Strategic and Site-Specific Assessment Merit Summary

Gateway Determination – Refusal (dated 12th November 2024)

Planning Proposal PP-2024-295 - 2 Brisbane Grove Road, Brisbane Grove. 2580

Figure 5 – Extent of Riverine Flooding Map (Source: Planning Proposal document).

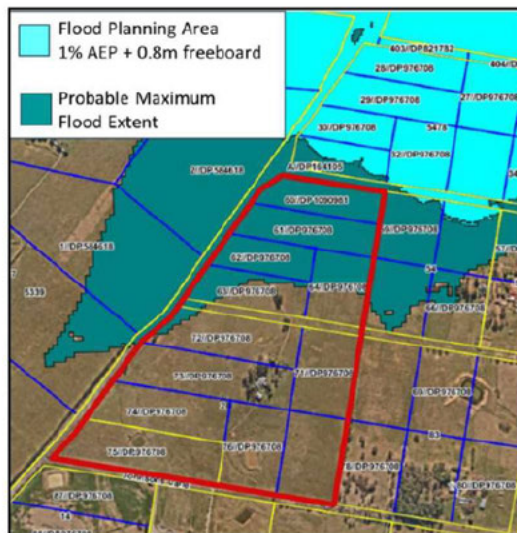
A Flood Impact Risk Assessment (FIRA) (Appendix 16a), which was prepared by the proponent in support of the planning proposal, classifies the site as a flash flood catchment (defined as flood occurring within 6 hours of the weather event and often involves rapid water changes to flood water velocity).

The FIRA identifies that Braidwood Road, which is the evacuation route from the site to the Goulburn CBD, will be inundated for 23 hours during a 1% AEP flood, 38 hours during the PMF and that isolation of the site can occur during events rarer than 5% AEP.

The limited available flood warning times for the site largely rules out evacuation as a suitable emergency management response during these flood events. Council proposes that residents shelter in place in their own flood-free homes until flood waters subside.

2. Flash flooding is "flooding that occurs within 6 hours of the precipitating weather event and often involves rapid water level changes and flood water velocity." The design rainfall event for the 1% AEP data presented in the FIRA submitted with the land rezoning proposal has a 36 hour duration. From the commencement of the design rainfall event it takes approximately 26.50 hours for flood water to begin overlapping the Braidwood Road traffic corridor. Note also that the smaller event magnitudes have longer response times to flooding – if they result in flooding at all. For the PMF the PMP (probable maximum precipitation) is a 24 hour duration with a 6 hour response time until water begins to overtop Braidwood Road.

3. Flash flooding can be more dangerous than long duration flooding. This is largely due to the rapid changes in velocities and depths of water, and the very short or minimal warning time providing limited opportunity for communities to respond to a flood threat in an appropriate and timely manner. The long lag times for the more frequent to rare rainfall events suggest that the site is not subject to 'flash flooding'.

4. The guideline considers shelter-in-place where flash flooding is the only flood risk present at the site and where people can safely shelter above the probable maximum flood level. The nominated dwelling site within each of the new allotments is above the probable maximum flood level and therefore 'THE SITE' is not subject to flooding.

It is further noted that 23 hour period of 'isolation' for the 1% AEP event is measured from the commencement of flood water overlapping the roadway. At either side of the peak flow the water depths are quite innocuous and are deemed passable under the flood hazard classification system.

Figure 8 – Flood Depth Map Along Braidwood Road Evacuation Route

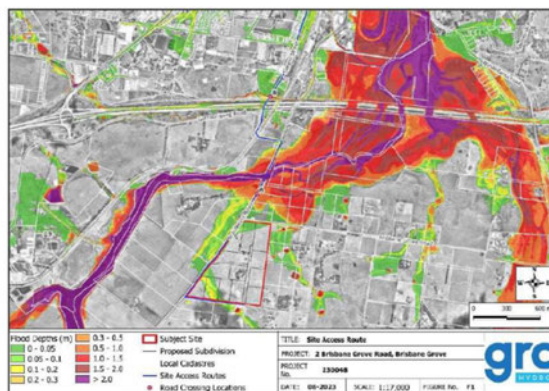
The FIRA identifies that isolation of the site can occur due to flooding of Braidwood Road during events rarer than a 5% Annual Exceedance Probability (AEP), with the road flooded for approximately 23 hours during the 1% AEP and 38 hours up to the Probable Maximum Flood (Table 7a).

The limited available flood warning times for the site largely rules out evacuation as a suitable emergency management response during these flood events. Council proposes that residents shelter in their own flood-free homes until flood waters subside.

different physical attributes and age, vehicles of different sizes, and different types of buildings and structures.

'H1' hazard with a water depth of 300mm or less and a velocity of less than 2.0 m/sec is safe for all groups, vehicles, and uses. 'H2' hazard with a water depth of 500mm or less and a velocity of less than 2.0 m/sec is safe for all groups, large vehicles, and uses [at 'H2' small vehicles are deemed to be unsuitable to pass through water]. Refer to the following Table retrieved from the *Australian Rainfall & Runoff Revision Projects, Project 10, 'Appropriate Safety Criteria for Vehicles – Literature Review'* (February 2011) for a definition of different vehicle types in flood conditions.

Table 7a - Depth and Duration of Flood Inundation of Braidwood Road for various flood events (Source FIRA, grc Hydro, August 2023).

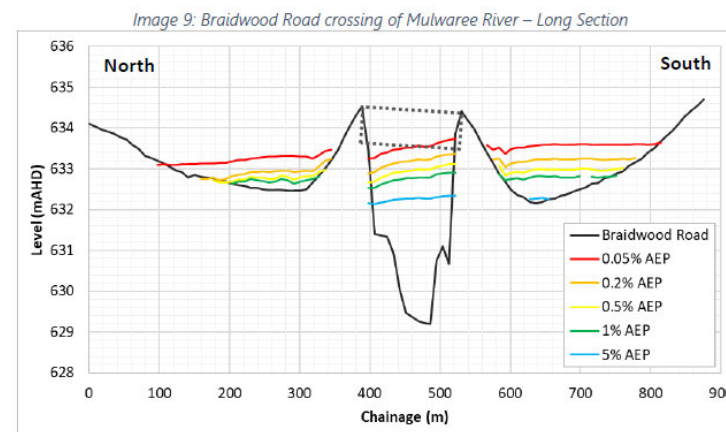
It is also noted that the flood hazard on either side of the Thorns Bridge crossing along Braidwood Road is not the same with the depths and velocities on the northern side of the crossing generally being less than the southern side for the same event magnitude – refer to the following image from the FIRA prepared in support of the land rezoning planning proposal.

With specific reference to the last dot point in the adjoining column: **"concern the entirety of the site becomes frequently isolated from vehicular access/egress in at least the 10% AEP event .."** – this has been raised for the first time amongst all other comments and responses. It is unclear where the data used for the 10% AEP reference has come from, and it is inconsistent with the FIRA submitted in support of the planning proposal, as well as the information derived for the Goulburn FRMSP.

With reference to the above long section of the Braidwood Road crossing, flood water only begins to flow across the roadway in the events equal to or greater than the 5% AEP.
